PLANNING AND ZONING COMMISSION

Monday, June 27, 2016

<p>SUBJECT: Consider making a recommendation on the Preliminary and Final Plat for Elmerodo Estates Plat 4, subdividing 13.53 acres into one lot, one outlot, and one street lot. The property is located west of NW 100th Street and approximately 275 feet south of the Johnston city limits (PZ Case 16-20).</p>	
<p>SYNOPSIS:</p>	<p>The applicant, Mark Shryock, wishes to subdivide the subject property into one lot, one outlot, and one street lot. Proposed Lot 1 would contain the existing home on the property. Proposed Outlot V is intended for future development. Proposed Lot ‘A’ would be deeded to the City for street right of way.</p>
<p>RECOMMENDATION:</p>	<p>Staff recommends approval and provides the following motion for the commission’s consideration:</p> <p>The Planning & Zoning Commission recommends approval of PZ Case No. 16-20, the Preliminary and Final Plats for Elmerodo Estates Plat 4, with the following conditions:</p> <ol style="list-style-type: none"> 1. The project shall be in conformance and in accordance with the requirements, standards and regulations of the City of Johnston, and any other requirement of state or fede

PRELIMINARY PLAT

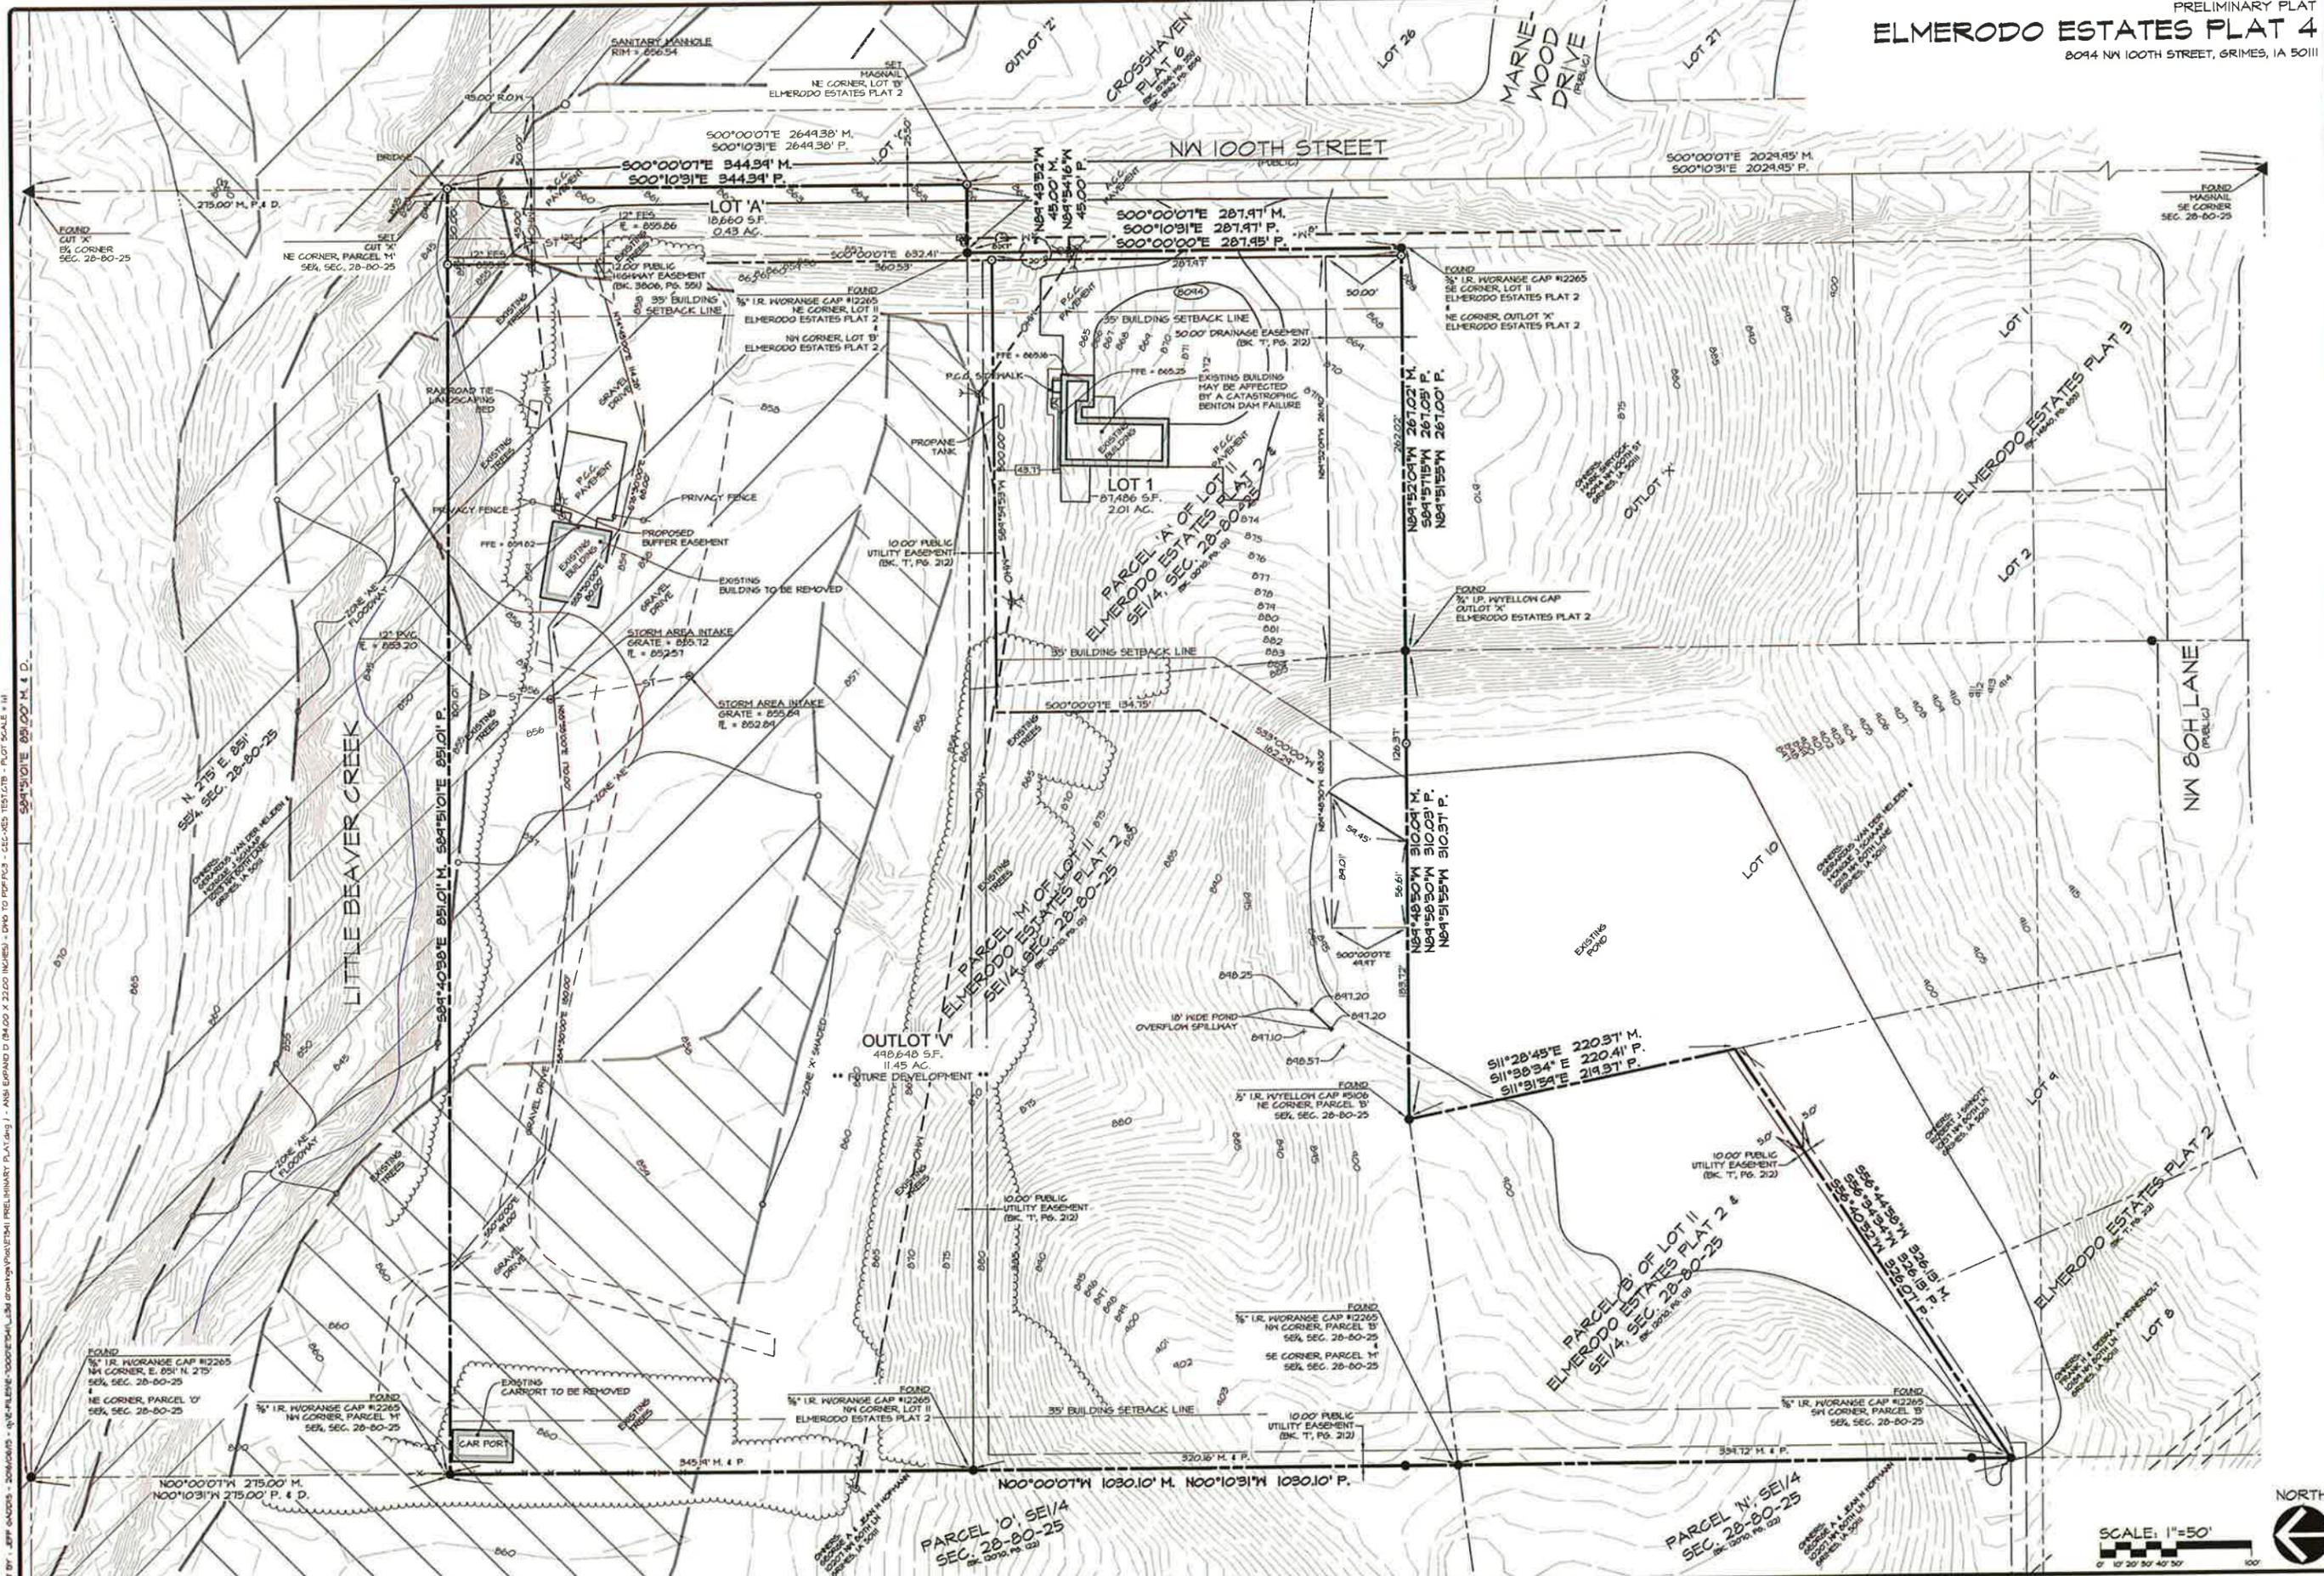
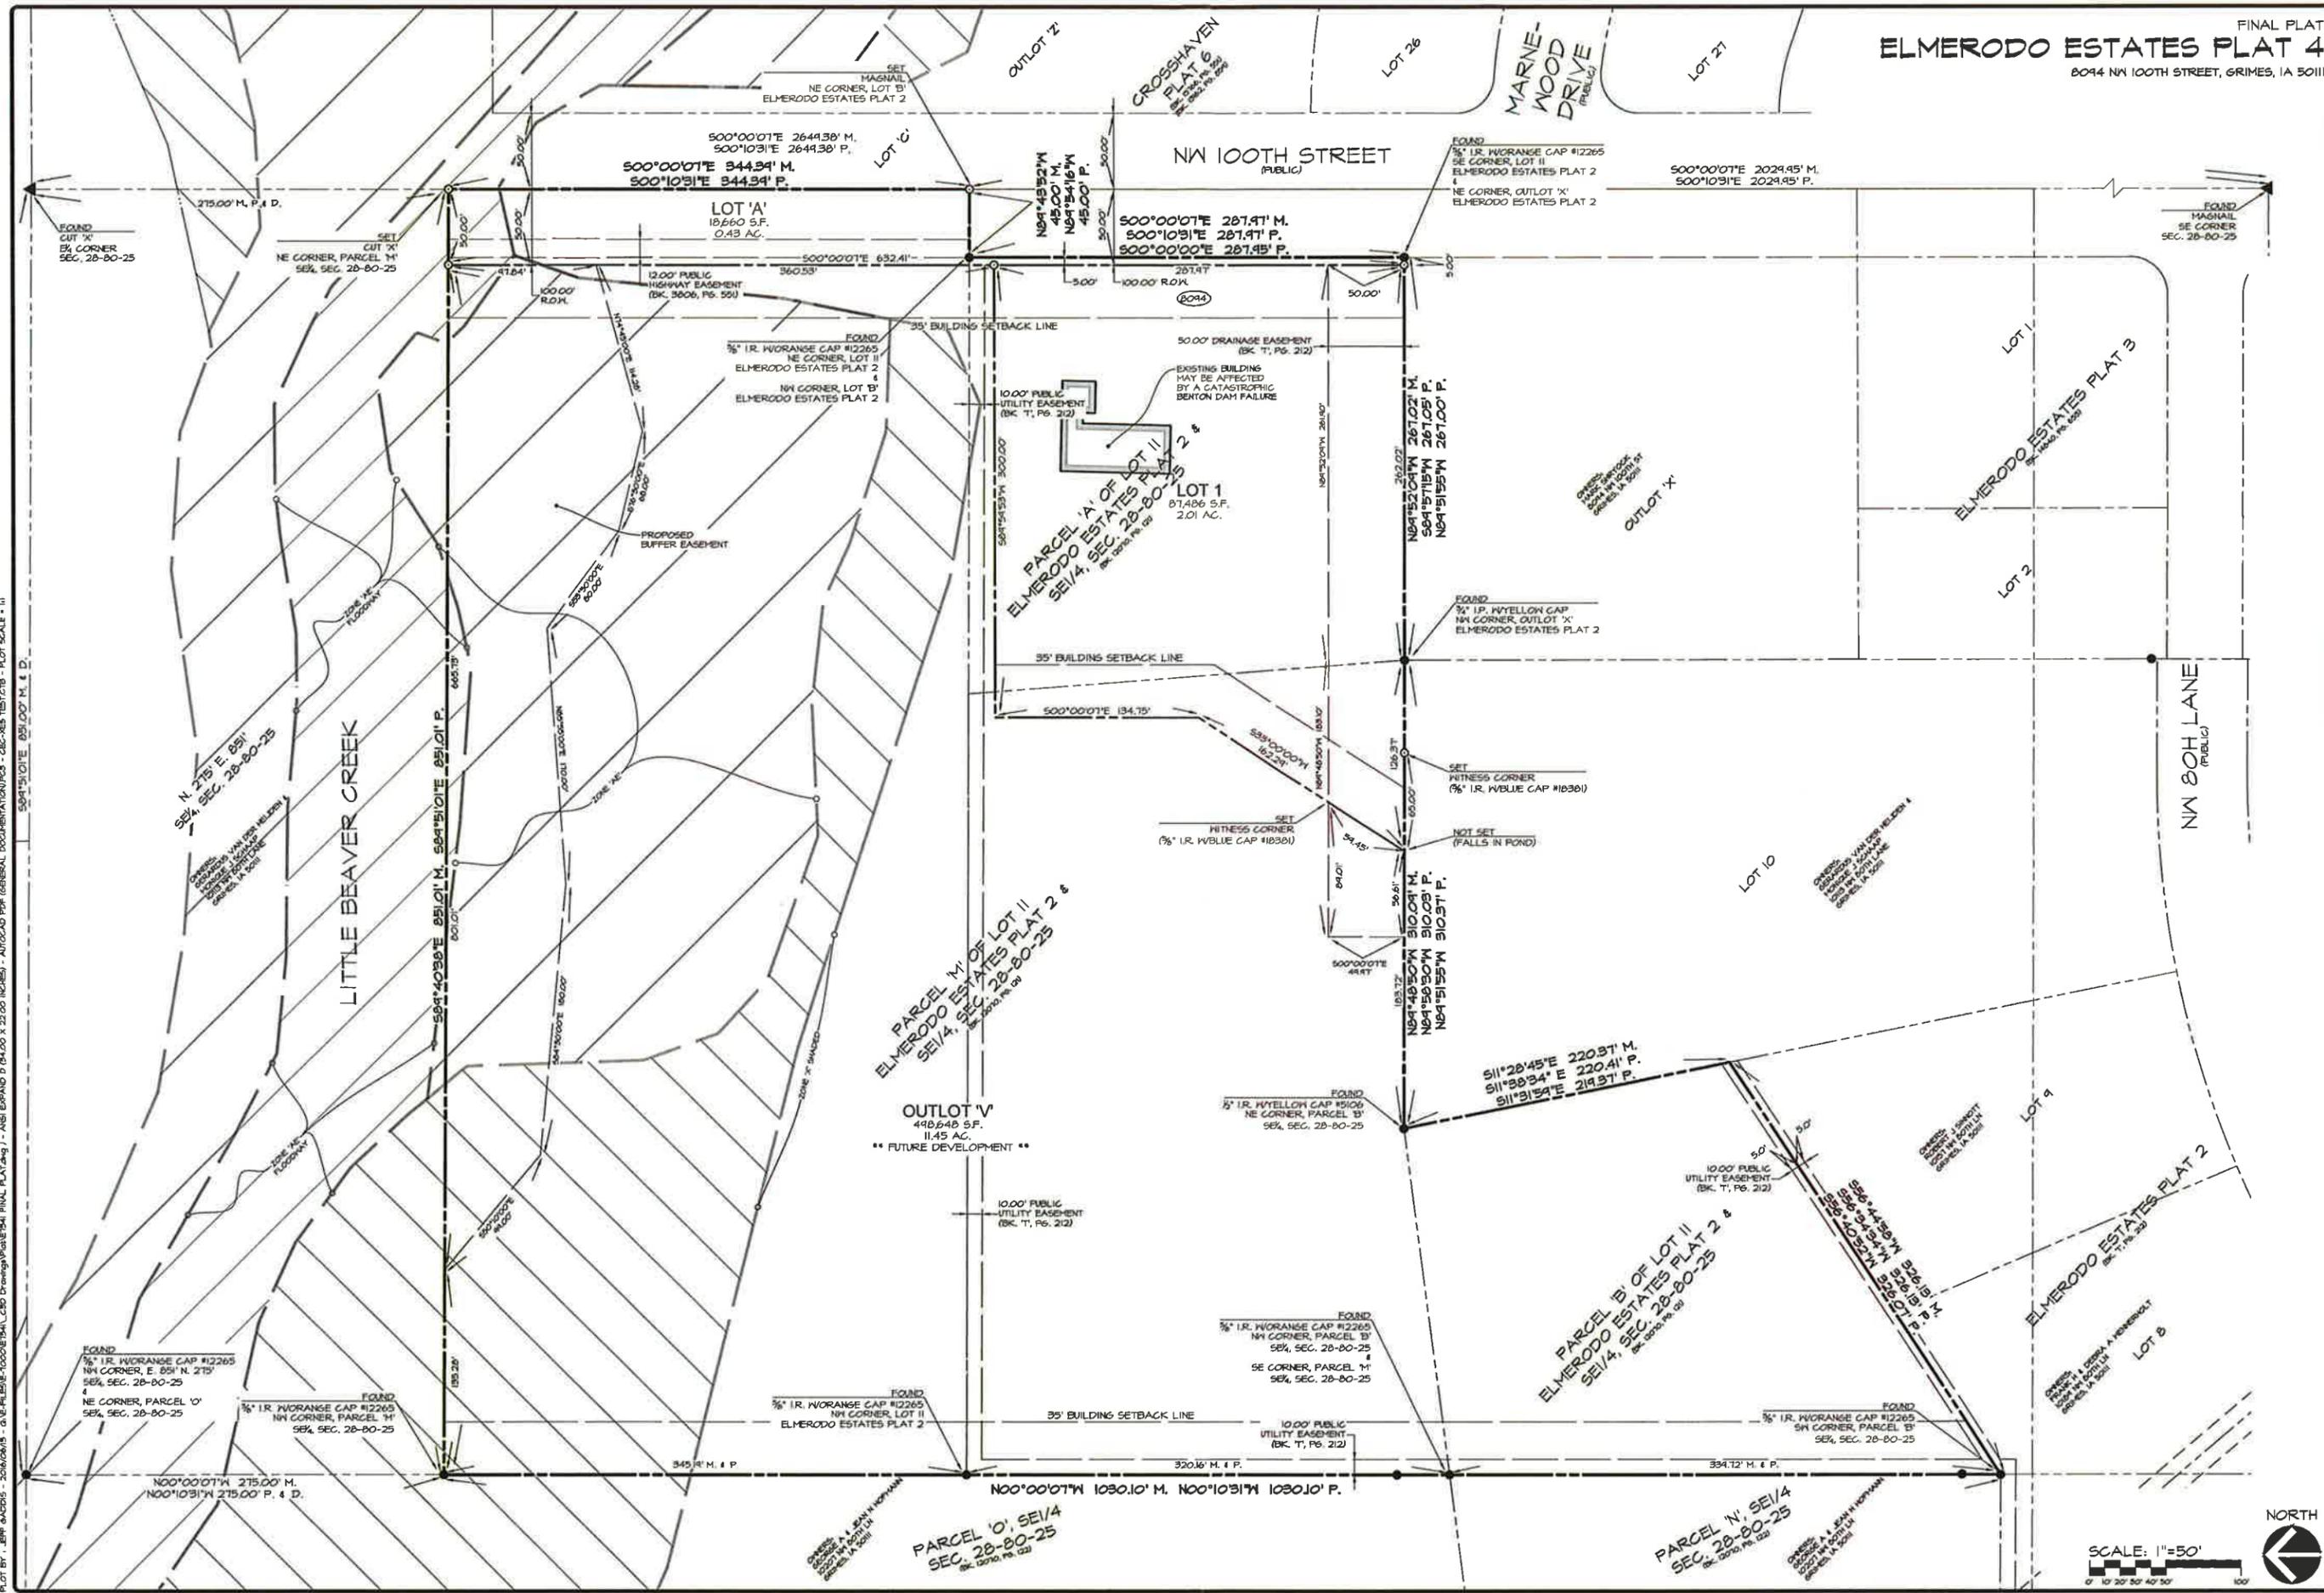
Staff has requested that the Iowa DNR advise on this development proposal. Staff is recommending a condition of approval that due to the lack of an existing maintenance agreement, the property owners of the proposed Lot 1 and Outlot V will have ownership/maintenance responsibilities for their portions of the existing dam/pond. It is recommended that the affected parties develop a permanent maintenance agreement and begin to take steps to ensure that the Benton Dam is no longer classified as a deficient dam by the Iowa Department of Natural Resources. Any modifications to the dam shall be permitted and inspected by the Iowa DNR and should give consideration to potential future development downstream of the dam.

The dam was designed for and meets current Department criteria for a low hazard dam, however, it does not meet criteria for a dam now rated as moderate hazard. The Department will consider the dam to be in a deficient state. Upgrades to the dam such as larger spillways, raising the dam, or lowering the pool may be required to remove the deficient rating.
